ADDENDUM NO. 1

PROJECT NO: 1110169

TITLE OF PROJECT: Visitor Center Repairs and HQ Restroom Replacement

FACILITY LOCATION: Monahans Sandhills State Park

SHEET NUMBER
 C-09

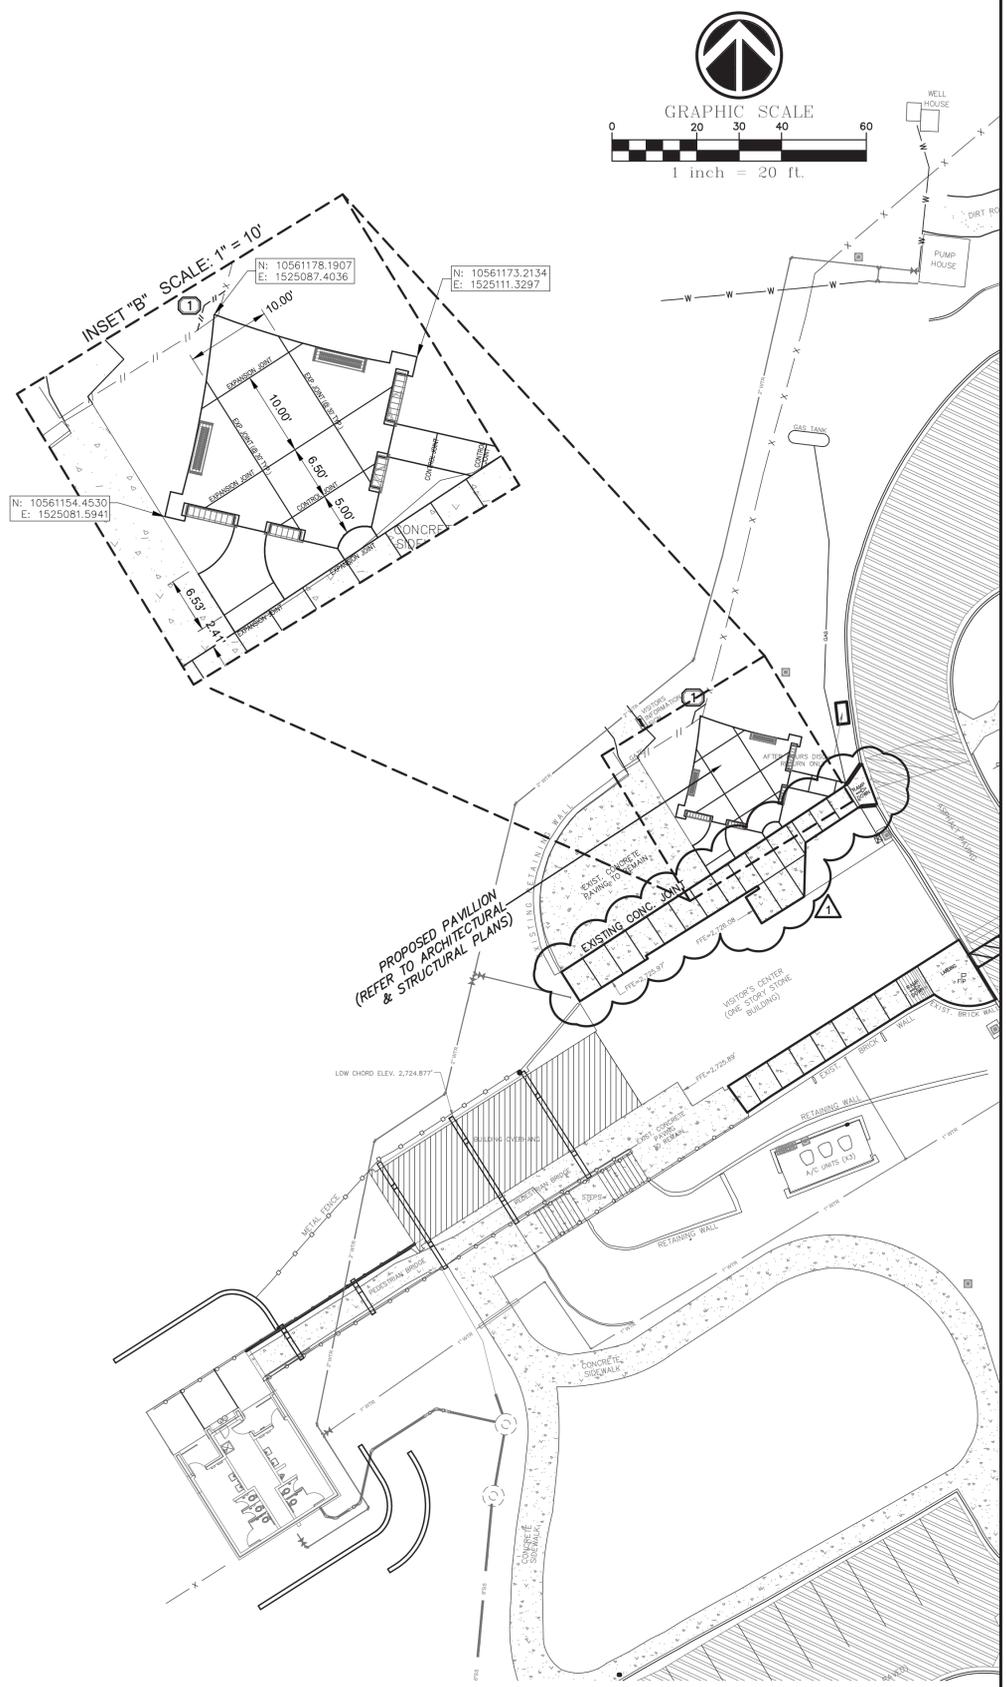
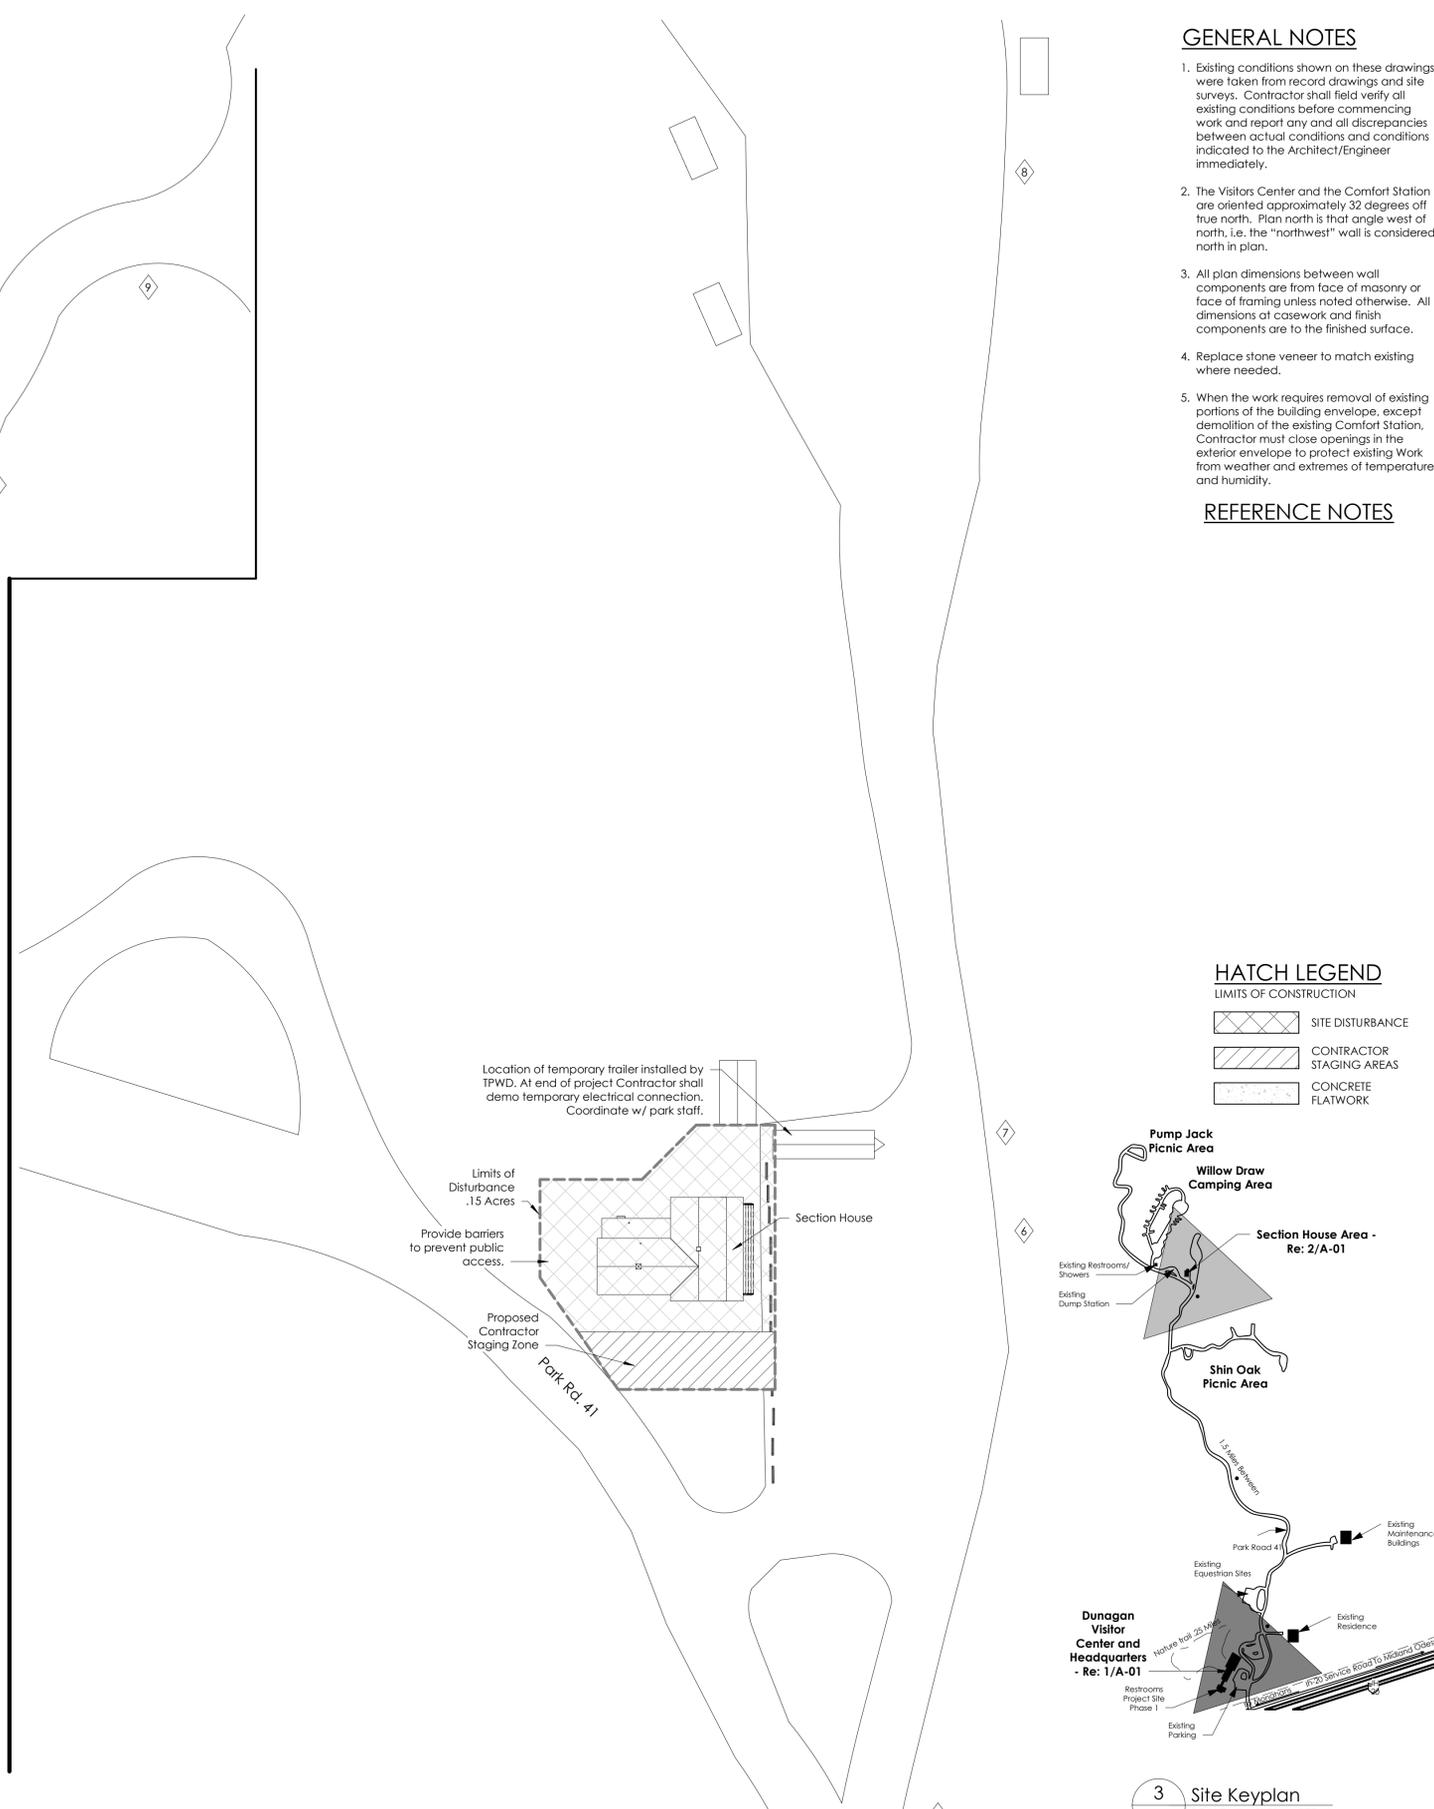
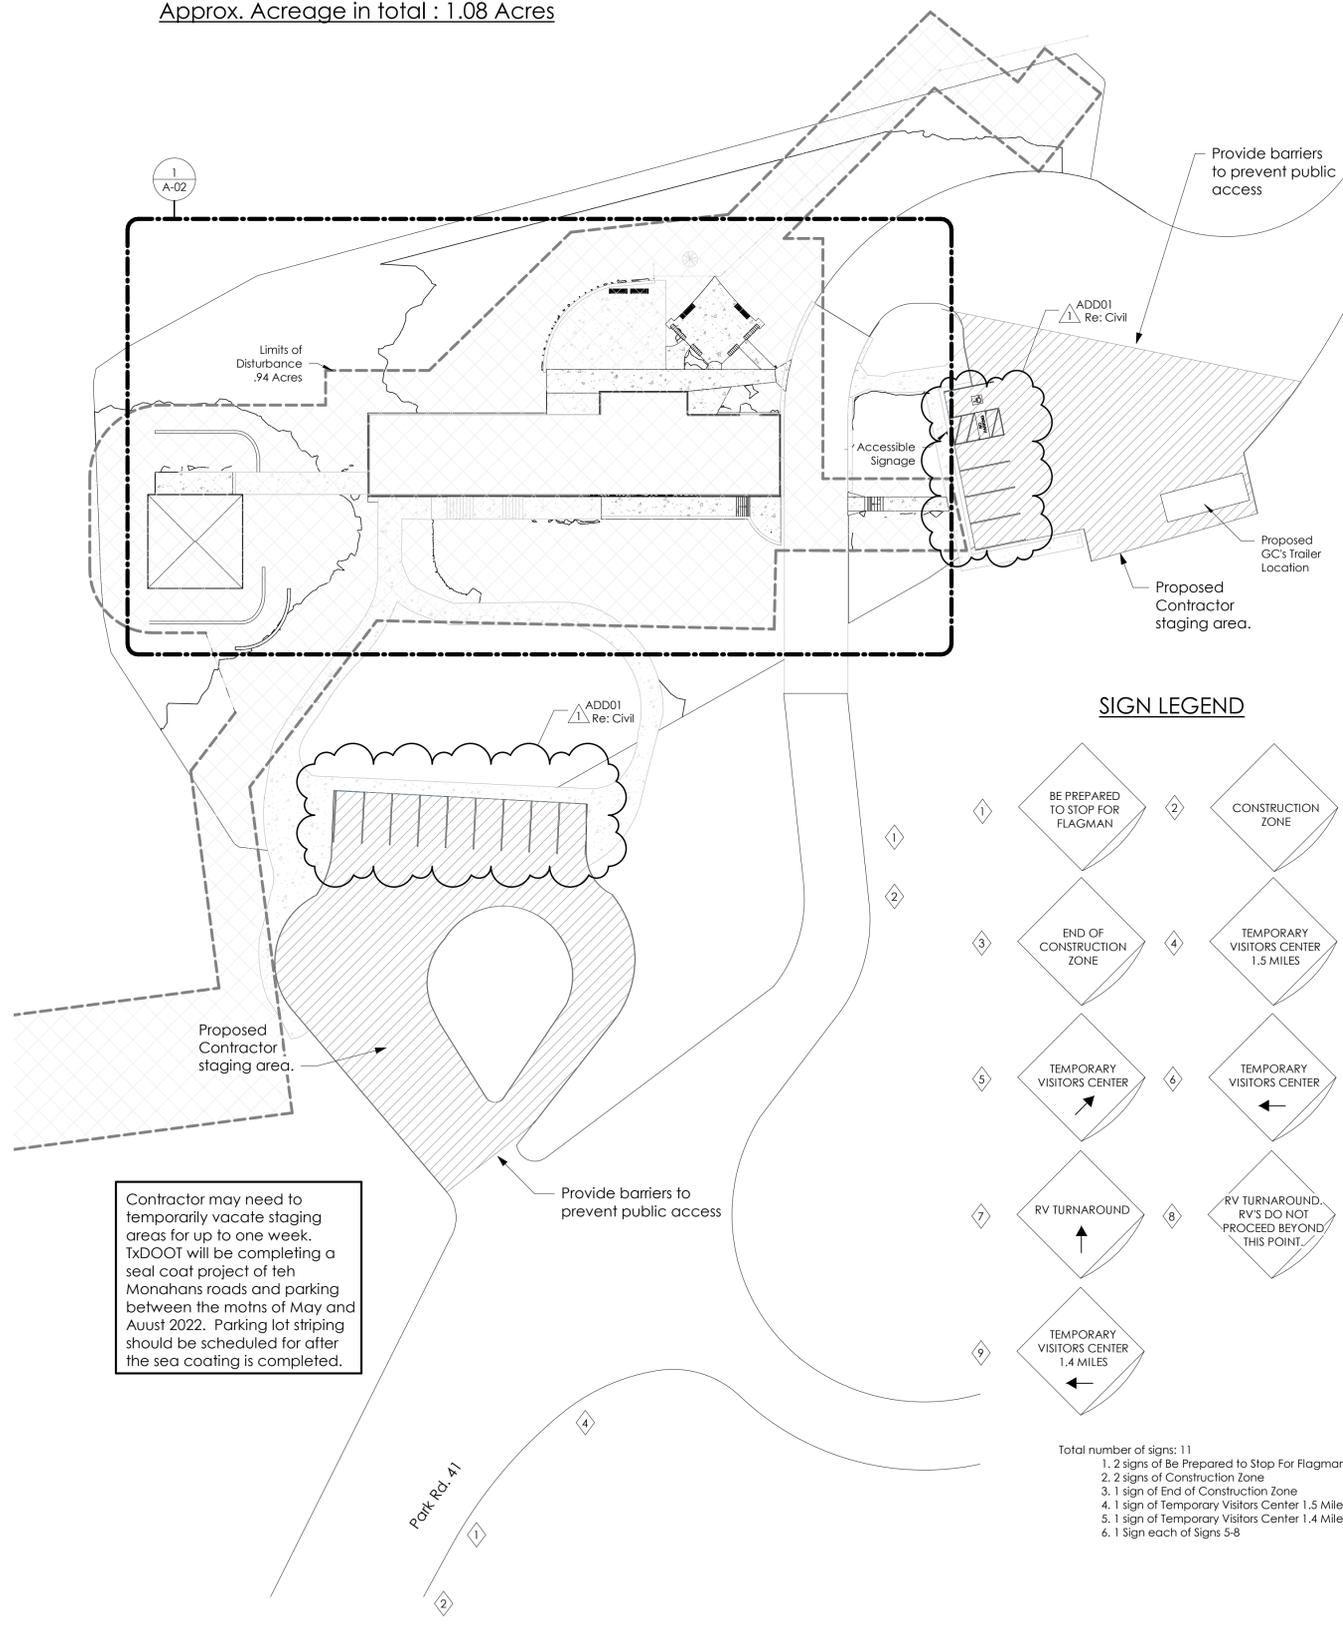
DATE: 03/19/2021
 DESIGNED BY: J.D.Z.
 DRAWN BY: J.D.Z.
 REVIEWED BY: C.C.
 REVISED:
 ADD 1 5/07/21
 SIDEWALK WAS STRAIGHTEN GRADES REVISED TO MEET ADA REQ.

1 VISITORS CENTER - WEST ELECTRICAL DEMO FLOOR

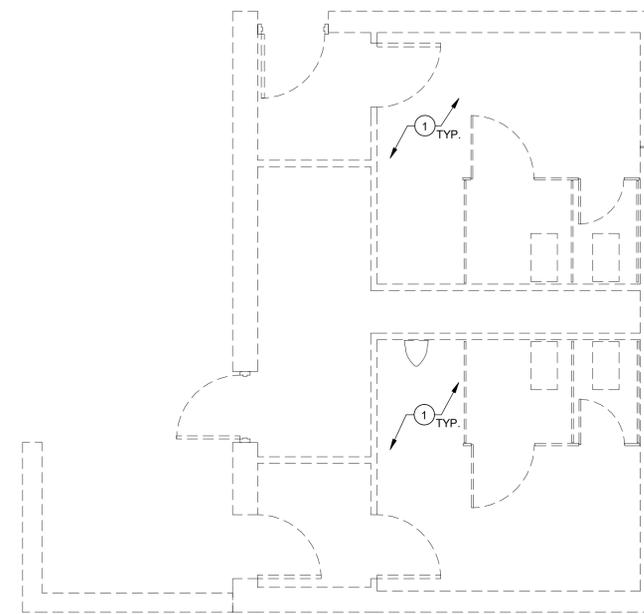
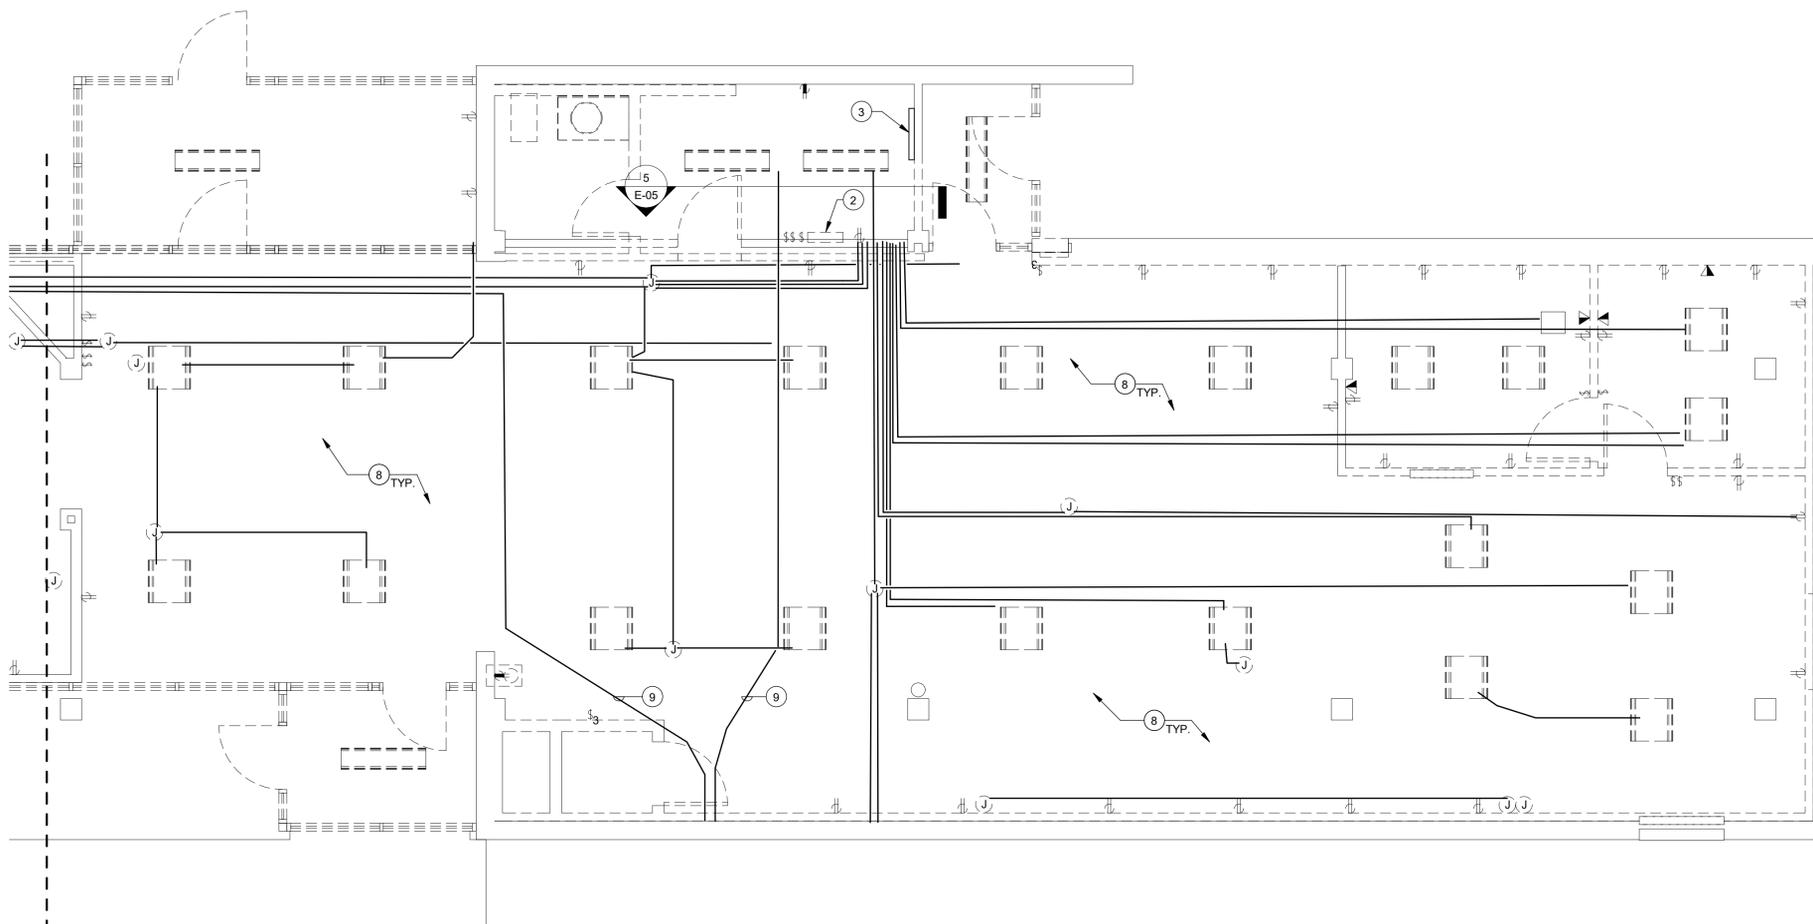
Q: In the existing electrical room, there is a communications pipe coming from underground (please see attached photos). Would this pipe need to be relocated to accommodate the new door or leave as is?

A: Demark well be called to be relocated and communication stub up will remain. Does not conflict with door. Refer to Addendum #1 sheet E-03.

1 EXISTING ELECTRICAL SCHEMATIC DIAGRAM
SCALE: NTS

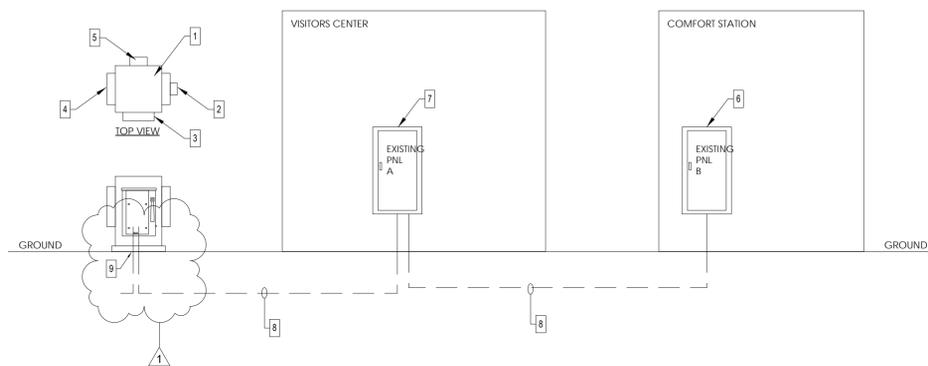
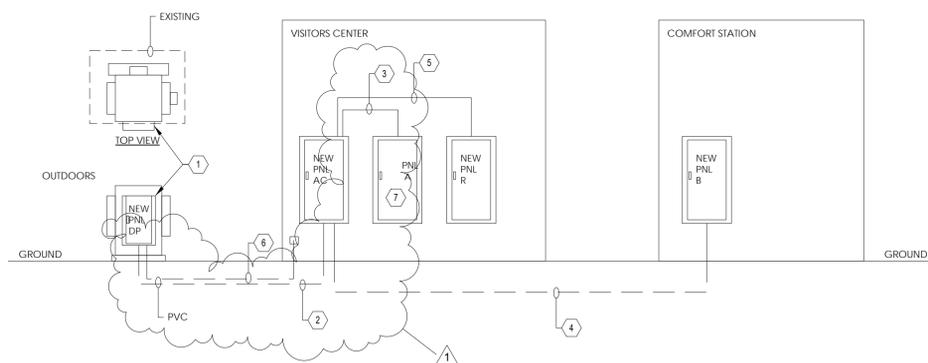
Q: The existing utility service pedestal to remain. Removing the 120/240V 3-phase, 200A service disconnect. To be replaced with a new Panel-DP. (please see the attached photos). There would not be a main to feed existing disconnect “A” and water well disconnect from panel-DP. The way the wires are tapped inside the pedestal from the load side of service disconnect “MS”. Would the 200A meter service be enough for panels DP, AC, A, and R with existing and future loads when added?

A: Existing Panel A will be feed from New Panel-DP loads will be revised. Refer to Addendum #1 sheet E-08/ detail #1 and #2.
